ADA Curb Ramp New Construction Inspection Form (Parallel)

Main	24952.54			Commercial	
North-South Road Name	Project No.	Sheet No.	Intersection No.	East-West Road Name	See https://www.oregon.gov/odot/Engineering/Documents_RoadwayEng/ADA_ExhibitA.pdf for more corner styles. Use Washington County corner numbering system.
Calibration Date				10/8/2024	(mm/dd/yy)

PARALLEL RAMP (PL)

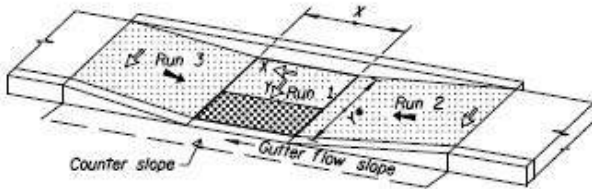
RAMP RUN 1		Pass	Fail
Running Slope 1	7.7 ≤ 2.0% <input type="checkbox"/> > 2.0% <input checked="" type="checkbox"/>		
Cross Slope 1	<input type="text"/> ≤ 2.0% <input type="checkbox"/> > 2.0% <input type="checkbox"/>		
Detectable Warning	N Y <input type="checkbox"/> N <input checked="" type="checkbox"/>		
Lip Height	0 ≤ 1/4" <input checked="" type="checkbox"/> > 1/4" <input type="checkbox"/>		
Gutter Flow Slope	3.9 ≤ * <input type="checkbox"/> > * <input checked="" type="checkbox"/>		
Curb Running Slope (avg)	<input type="checkbox"/> 4.08 ≤ 8.3% <input checked="" type="checkbox"/> > 8.3% <input type="checkbox"/>		
Counter Slope (+/-)*2	8.3 ≤ 5.0% <input checked="" type="checkbox"/> > 5.0% <input type="checkbox"/>		
Det. warning full width of ramp	<input type="text"/> Y <input type="checkbox"/> N <input checked="" type="checkbox"/>

RAMP RUN 2		Pass	Fail
Running Slope 2	<input type="text"/> ≤ 8.3% <input type="checkbox"/> > 8.3% <input type="checkbox"/>		
Length 2	7.4		
Cross Slope 2	14.3 ≤ 2.0% <input type="checkbox"/> > 2.0% <input checked="" type="checkbox"/>

RAMP RUN 3		Pass	Fail
Running Slope 3	<input type="text"/> ≤ 8.3% <input type="checkbox"/> > 8.3% <input type="checkbox"/>		
Length 3	7.3		
Cross Slope 3	13.3 ≤ 2.0% <input type="checkbox"/> > 2.0% <input checked="" type="checkbox"/>

No Td. Asphalt.
